ADDENDUM No. 1

ITB No. 4706

WWTP HEADWORKS IMPROVEMENT PROJECT

SCALE 1" = 20'	DRAWING No. 210
SHEET No. C-06

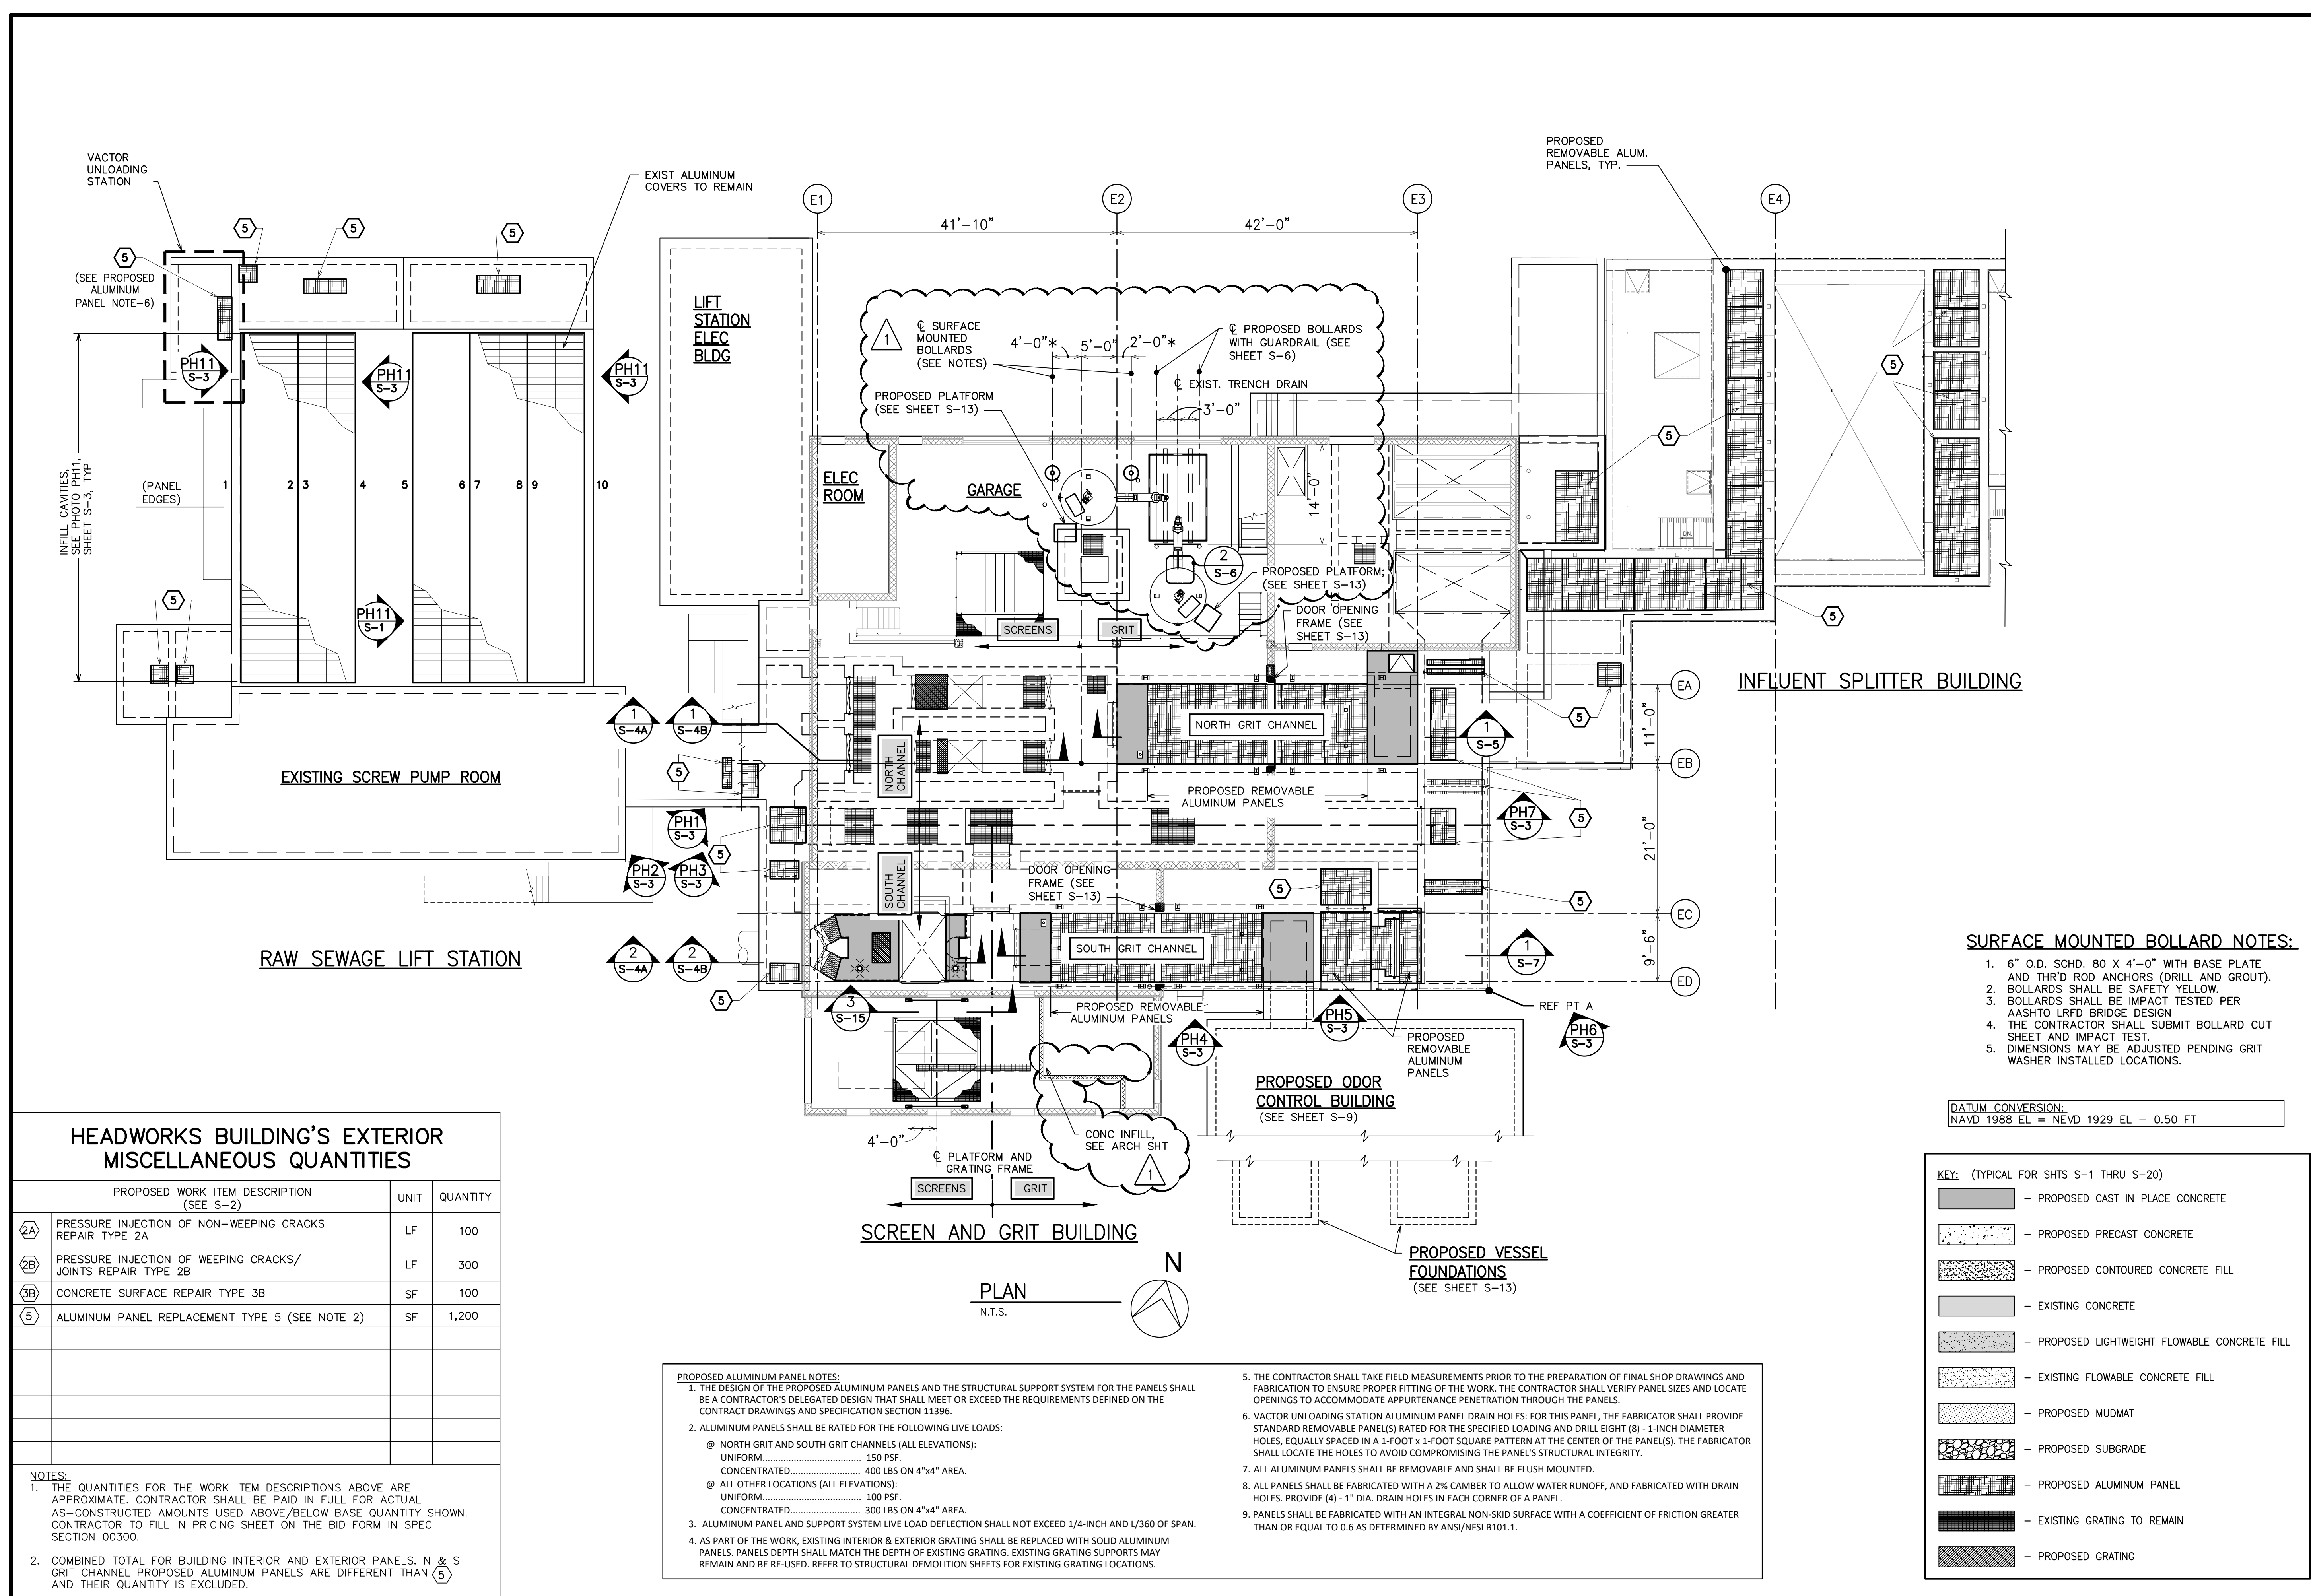
Comment: Sheet C-06 is reissued to coordinate roof drain outlet with revised roof drain plan shown on Sheet P-20 and to clarify site light relocation callout.

Question 31: Refer to sheets C-06, P-20 and M-07. The following questions are in regards to the natural gas system extension:

1. Please provide details of where we connect into the existing natural gas piping. We assume that connection to be somewhere in the Screen and Grit Building per drawing C-06.
2. Please provide natural gas pipe routing diagrams through the existing Screen and Grit Building to the MAU-1 Unit on the roof.
3. Please provide locations of the Gas Unit Heaters in the Odor Control Room.

Answer 31: (1) As shown on Sheet C-06 a new 1" gas feed to the Odor Control Room connects to the existing 1" gas line just south, outside the of the Screen and Grit Building.
(2) An existing MAU unit is being demolished per DM-01. The existing gas connection is to be utilized.
(3) Gas Unit Heater location to be included in Addendum No. 2.

SCALE: AS SHOWN
DRAWING No.: 406
SHEET No.: **A-6**

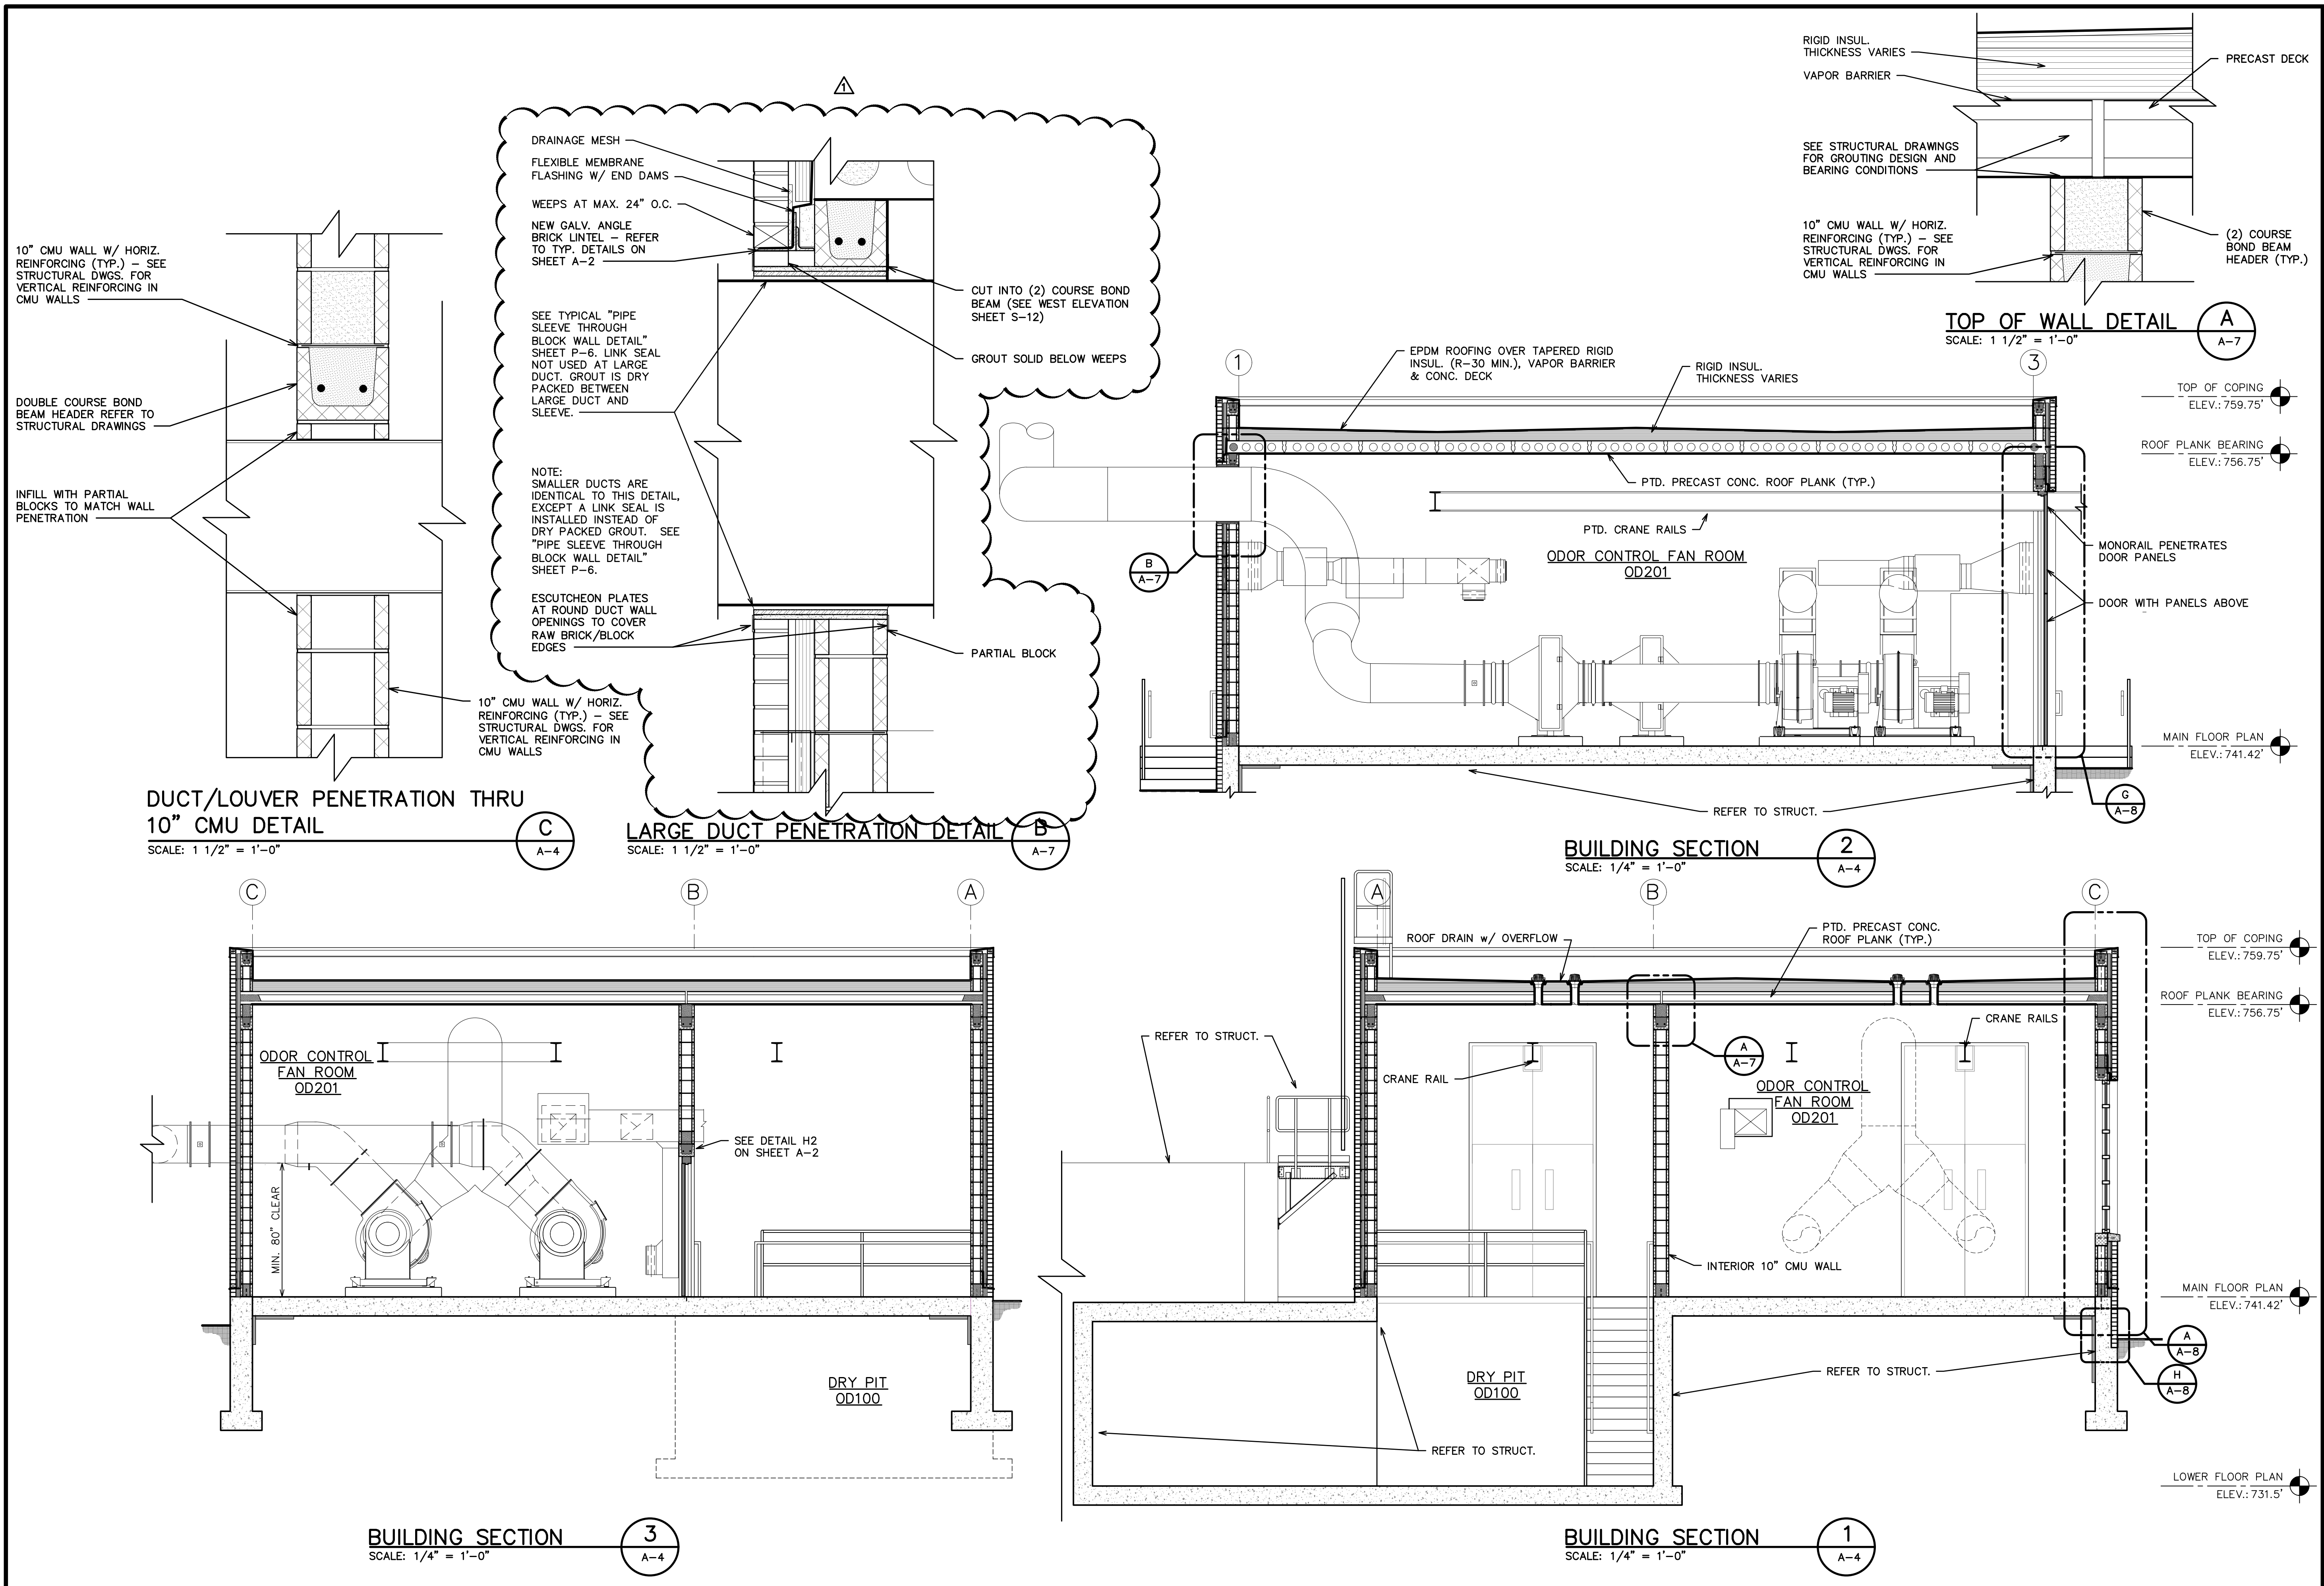
Question 39: On sheet A-6 the new building elevations shows a temporary guardrail system and the bid document did not specify that scope “Wood or metal guardrail system. Is that a safety fall protection kind system? Is there any approved Manufacture you would like me to quote?” please clarify.

Answer 39: Please see “NON-PERMANENT GUARDRAIL” notes on sheet A-5.

SHEET No. **P-14A**

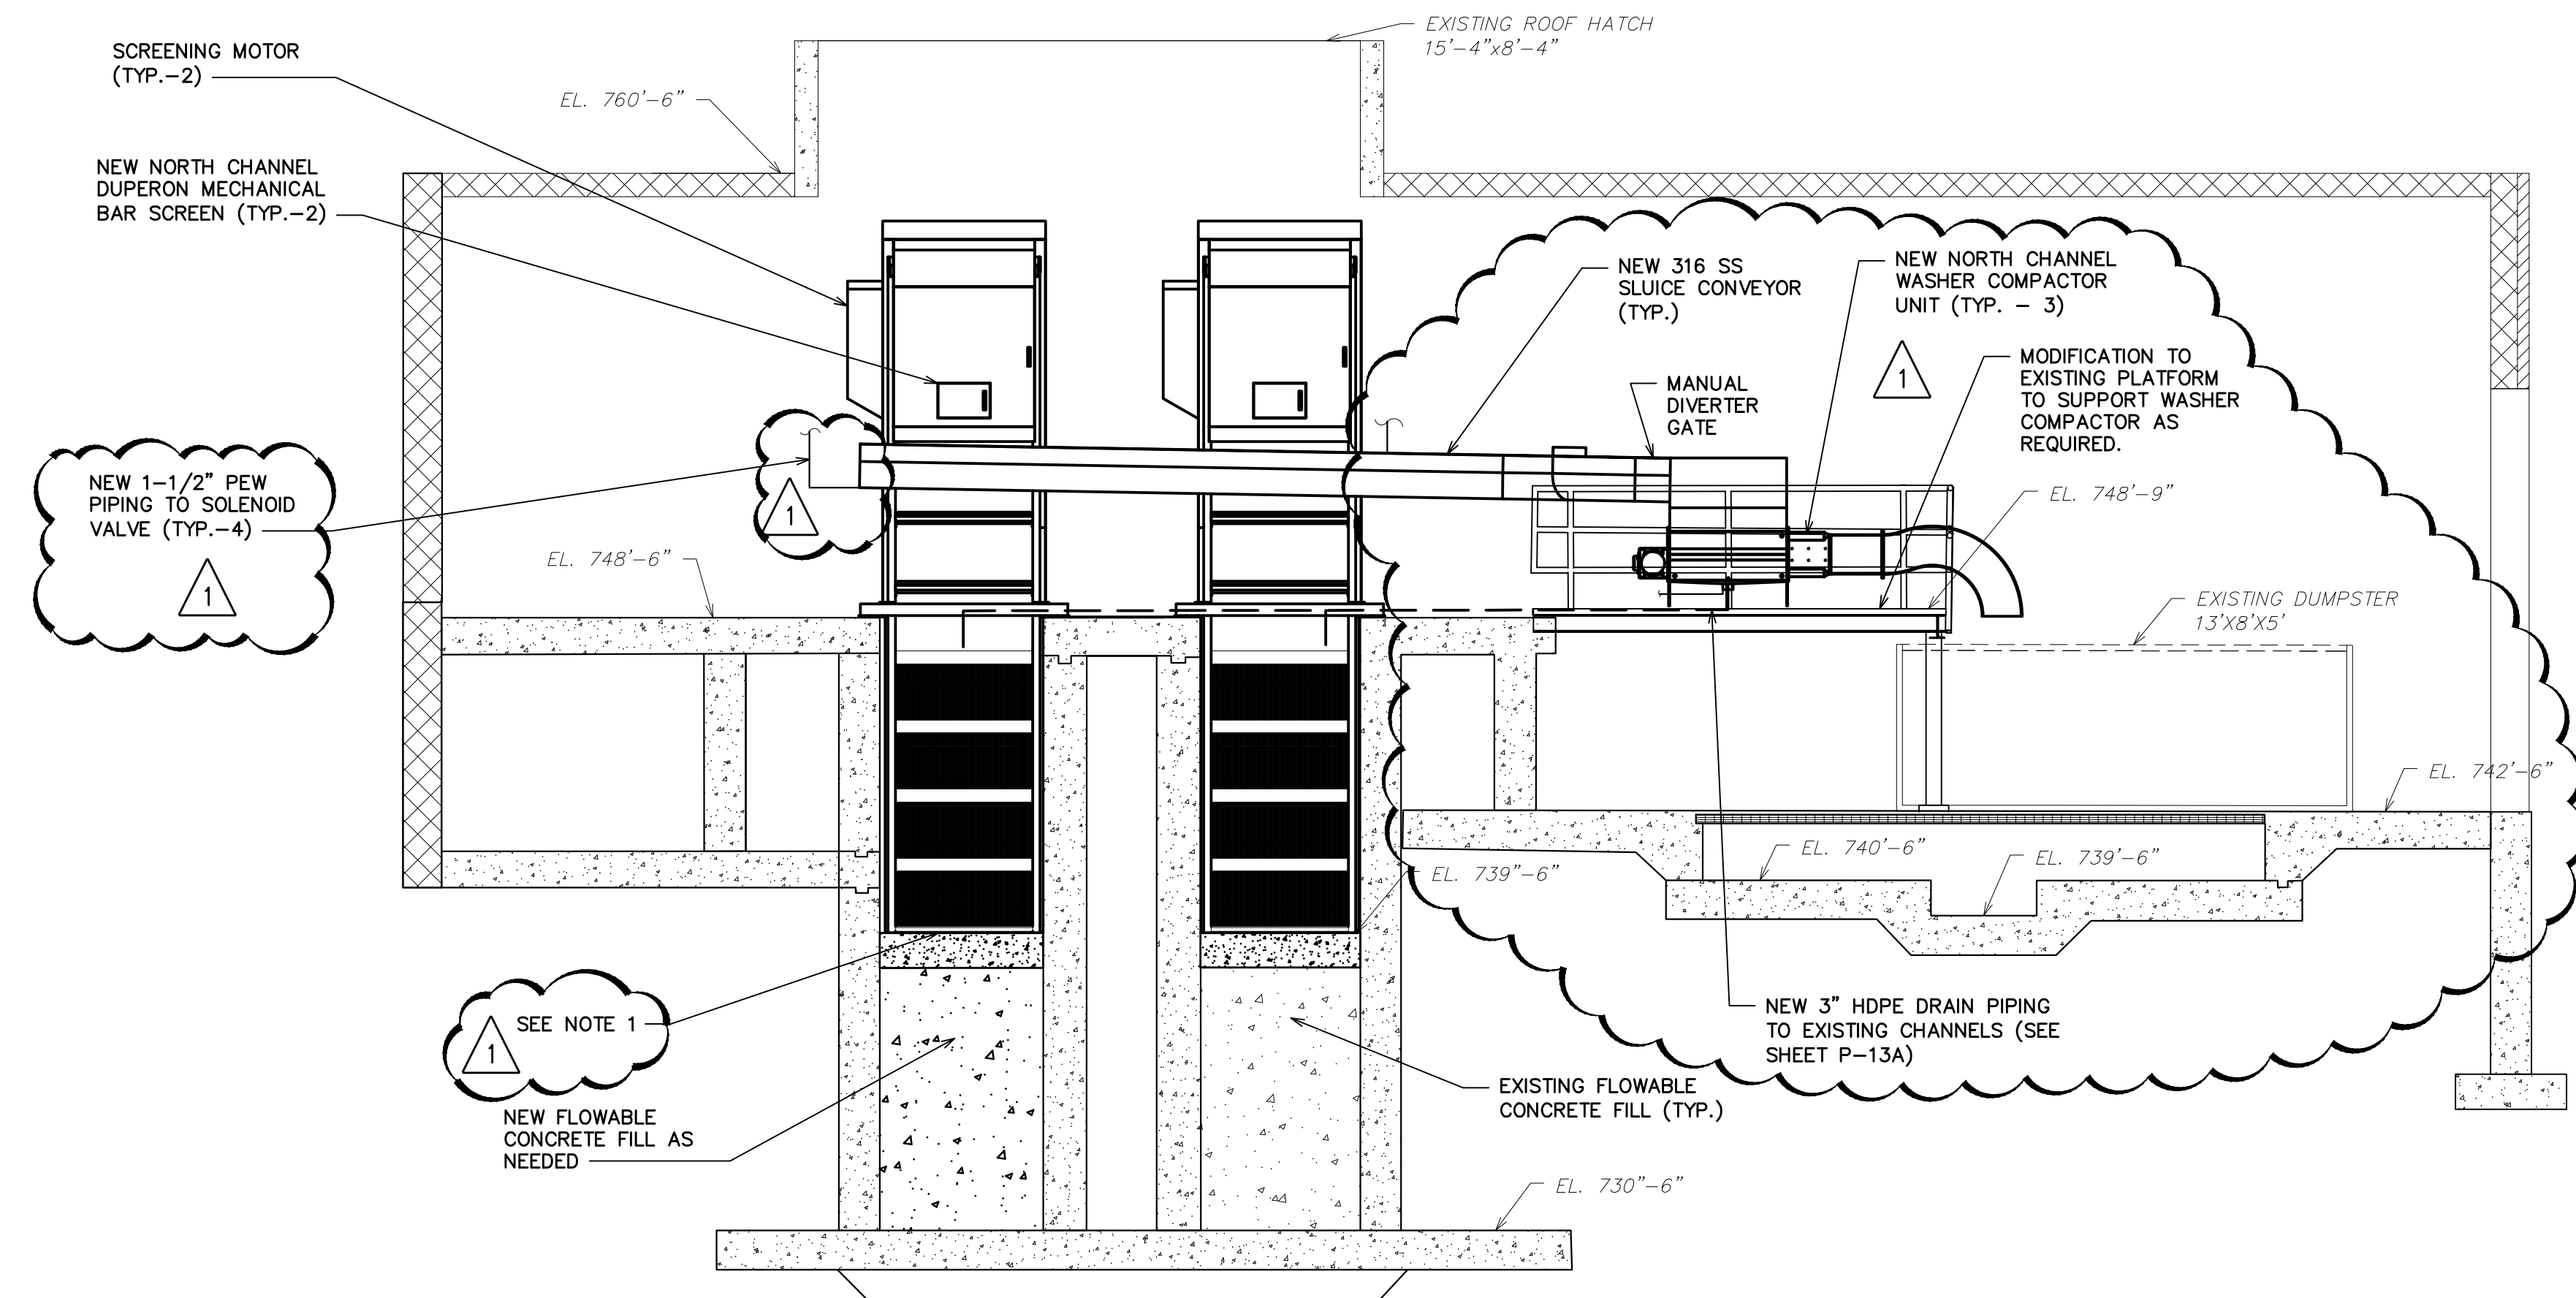
- P-15A** As updated herein:
Updated PEW piping connections and notes and sump pump requirements and notes.
- Comment:* *Purpose of additions are to coordinate with sheet P-02 (PEW system schematic in the Headworks Building), and specification 11133 and 08305.*
